SUNDRY NOTICES AND REPORTS ON WELLS

Wiser request approval to Plug & Abandon the well by procedure listed below.

WELL: 73-Shellby Unit LEASE NO.: LC-079418B

**Permanent Abandonment of Federal Wells  
Conditions of Approval**

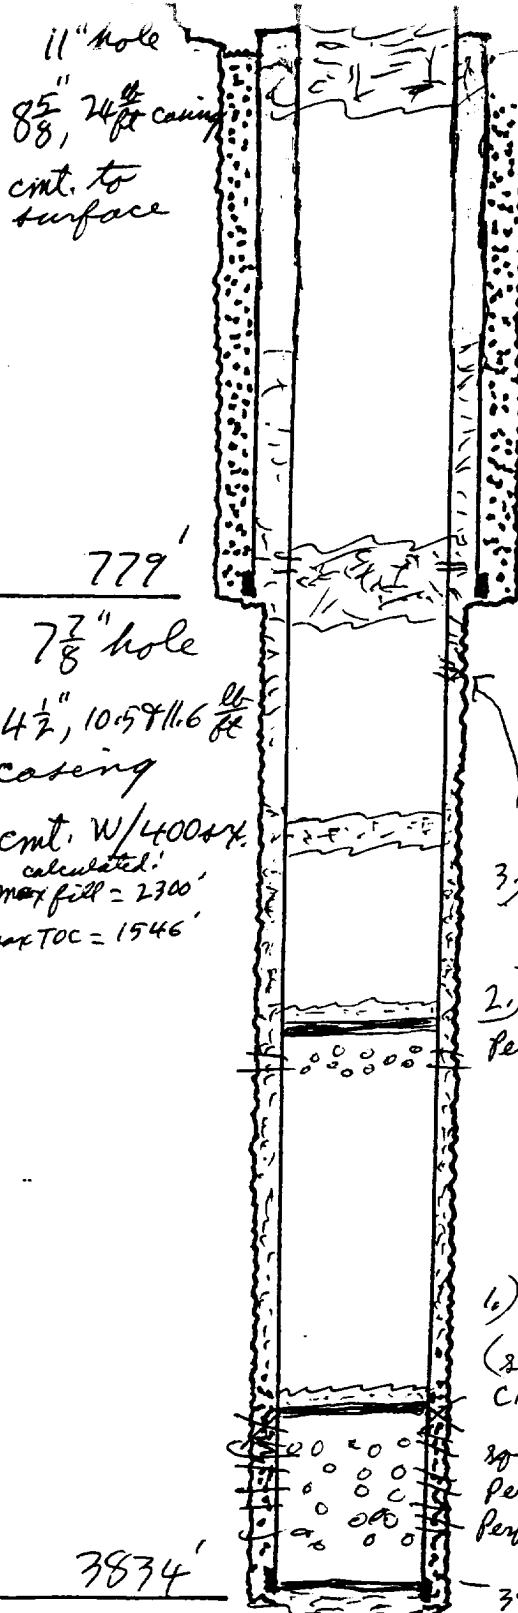
} BLM records show CIBP at 3250' w/ 35' cement cap

5.) Minimum 50' cmt. surface plug.

4.) 15' cmt. plug 780'.

3.) 25' cmt. plug 1600'.

2.) CIBP at 2300' + 15' cmt. cap.  
Perf 2340' - 2466' (Jan. '79)

1.) Existing plug.
